Re: Joyce Lake DS0 Iron Ore Project: Changes - December 13, 2022, Feasibility Study

This letter is to inform IAAC of key changes (the Changes) between the Draft EIS and the 2022 Study. JDI believes the Changes are not material and do not require significant additional consultation, adjustment to IAAC's Draft EIS technical review or collection of additional baseline data.

1. Site, Haul Road and Astray Loadout General Arrangement – 2022 Study

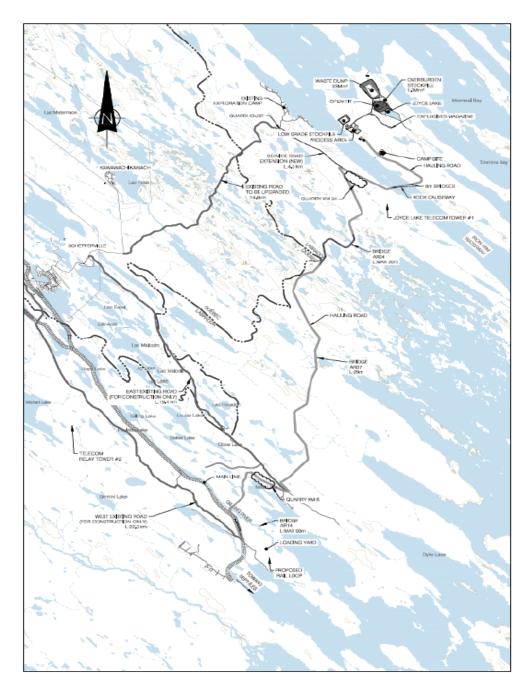
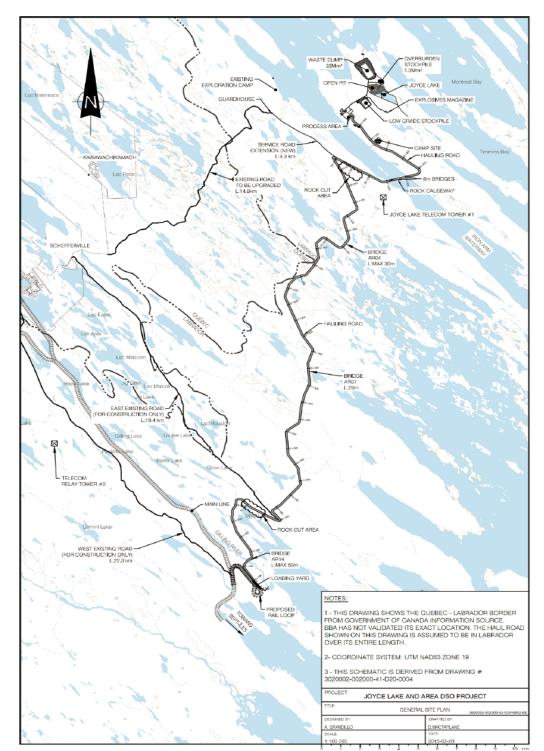
- Annually, transported tonnage is reduced by 17,500 tonnes of water
- Haul truck/train frequency is reduced by a third (reducing emissions intensity)
- Product storage capacity for rail and port transfers are reduced
- Haul truck/rail loadout workers are full time, rather than seasonal
- The Project is more economically robust
- A 875,00 DMT (peak) dried lump stockpile is located at the mine site crushing pad
- Diesel fuel consumption increases by 1.1ML/a or 5.39% annually.
- b. The dedicated product haul road between the mine site and Astray rail loadout uses the same route, but road width is reduced to a single lane with passing pull-outs at 1Km intervals. Continuous truck haulage requires only 12-95 t haul trucks.
- c. At the planned Astray rail loadout improved design now requires installation of 2.4Km of new track compared to 6.9Km previously.

2. Mine Site General Arrangement – 2022 Study

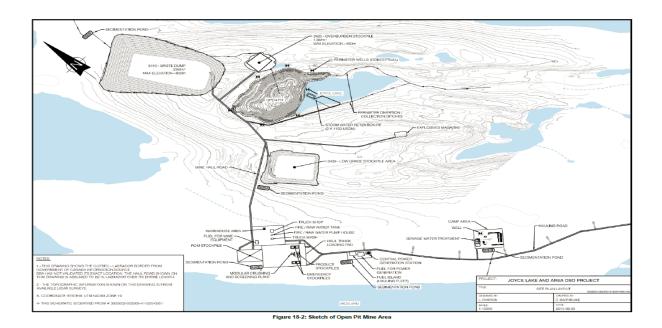
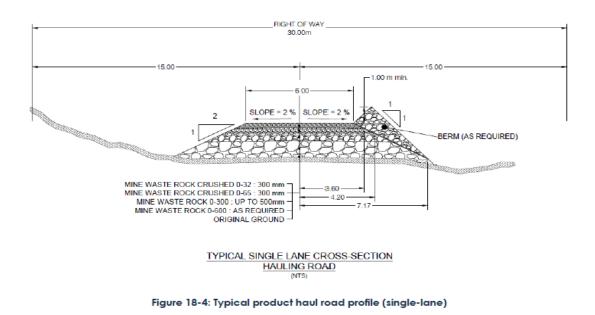
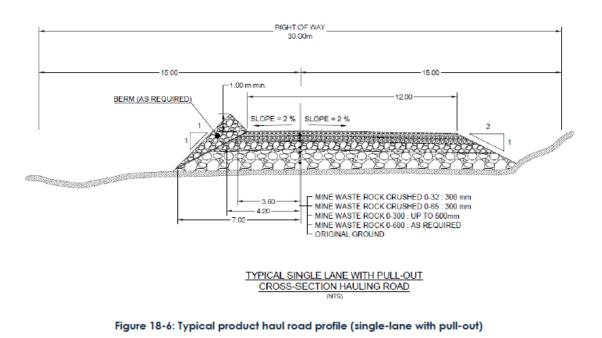
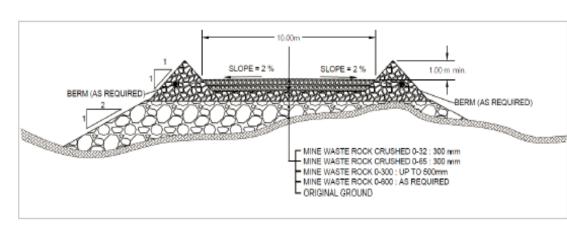
Additionally, the lower grade ROM stockpile, which will be reclaimed, and crushed and transported to market at the end of mine life, has been relocated from between the open pit and crushing pad, to the crushing pad at the mine site. The relocation reduces energy required during reclaim.
